For 200-400VAC Input to SCR

Title Volkman-Elmot.de Trigger Module Upgrade		
Author Fastron		
File U:\Reference Library ... AC Switch Wiring.dsn	Document	
Revision 1.0	Date 24/04/2023	Sheets 1 of 1

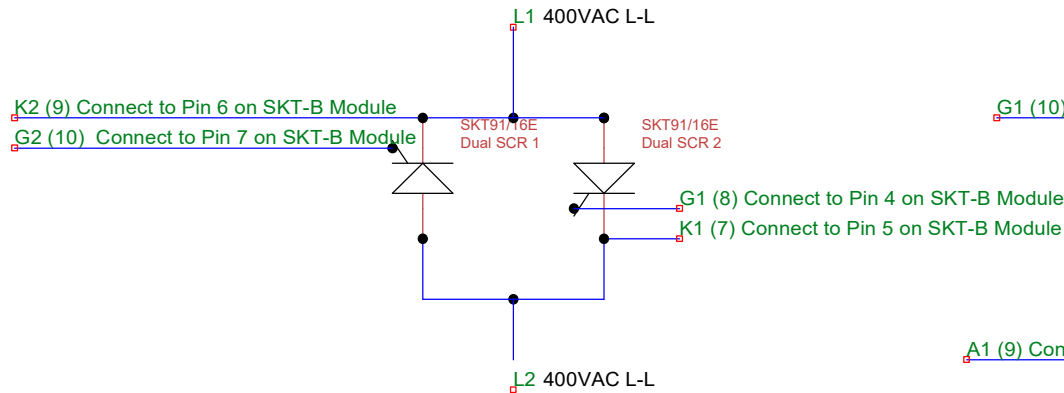
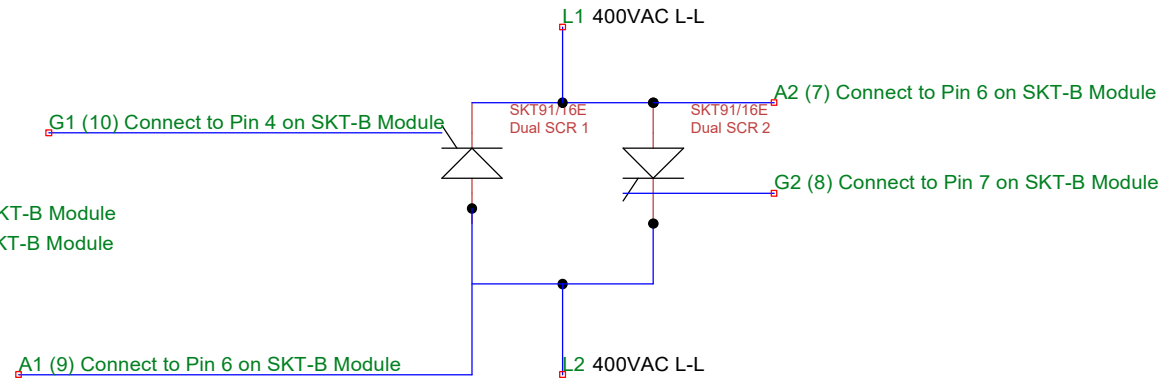
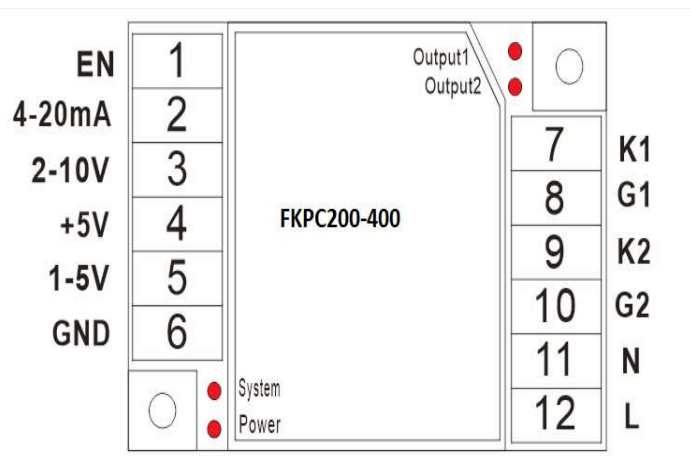
Note: L/N and K1,K2,G1,G2 must be 100% correct to have full Control

- To Change from Semikron to Fastron Unit.
- 1) Remove wire from A1 and Connect to K2
 - 2) Remove wire from A2 and Connect to K1
 - 3) All other connections the same
